BCA & ACCESS ASSESSMENT REPORT

REF Amendment Submission

Cowra Hospital Redevelopment

Revision: 3

Ground Floor Compartment Plan

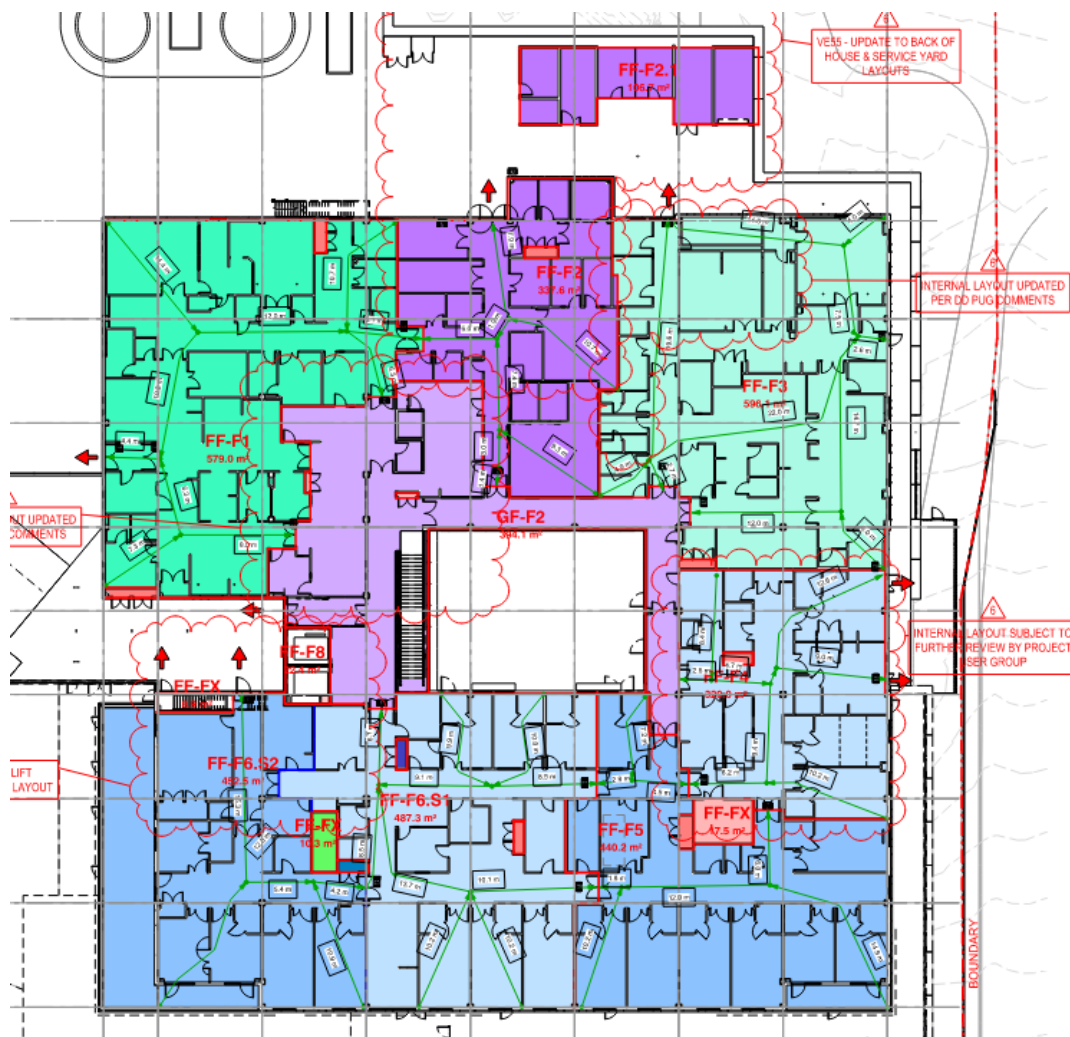
Fire walls are to comply with BCA C3D8. The building structure, including the steel roof structure, must be designed so as not to cross the fire walls.

Reservoirs are required over each of the fire doors (400mm reservoir)

The proposed compartment strategy is below:

First Floor Compartment Plan

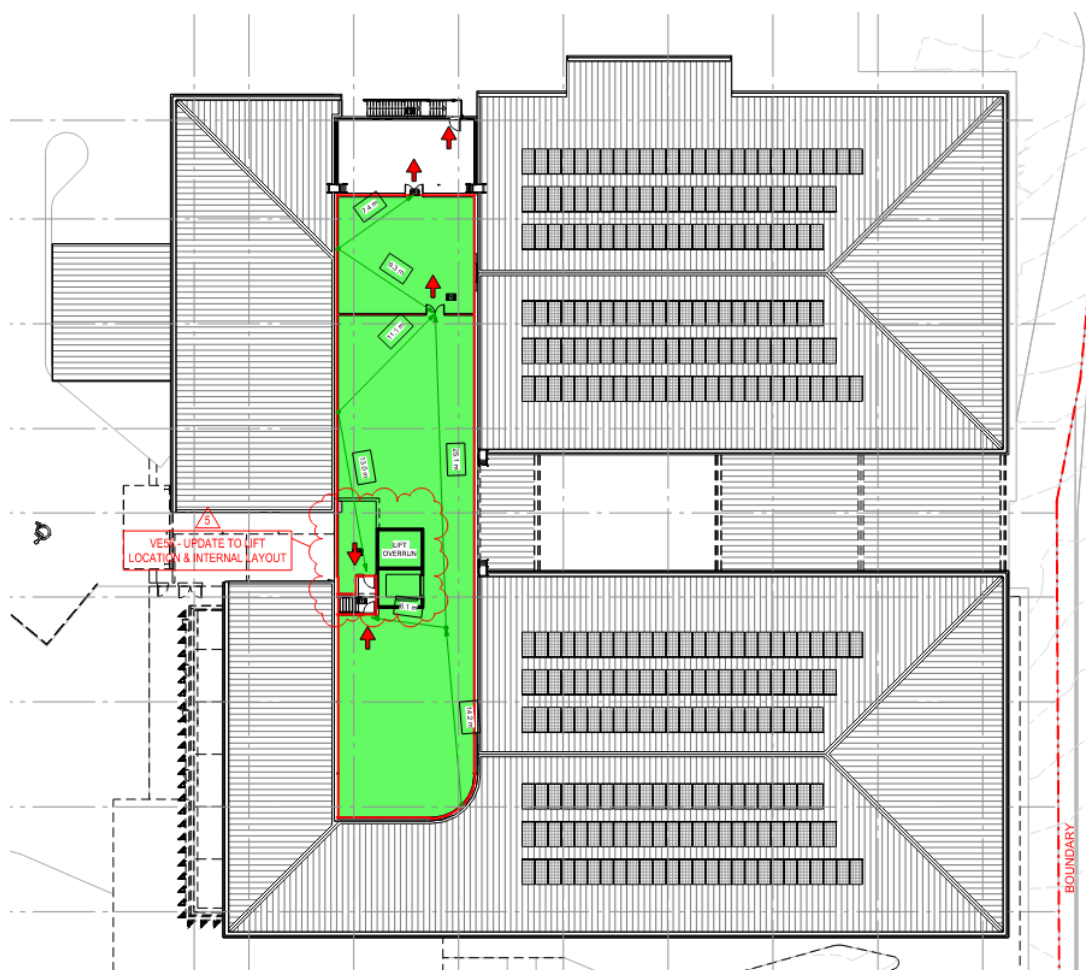
- + All fire walls are considered combined fire and smoke walls.
- + Ancillary use spaces are required to be 1-hour fire separated from patient care areas.
- + Ancillary use spaces in a Class 9a comprise:
 - A kitchen and related food preparation areas having a combined floor area of more than 30m².
 - A room containing a hyperbaric facility.
 - A room used predominately for the storage of medical records having a floor area of more than 10m².
 - A laundry, where items of equipment are the type that are potential fire sources (e.g. gas fire dryers).
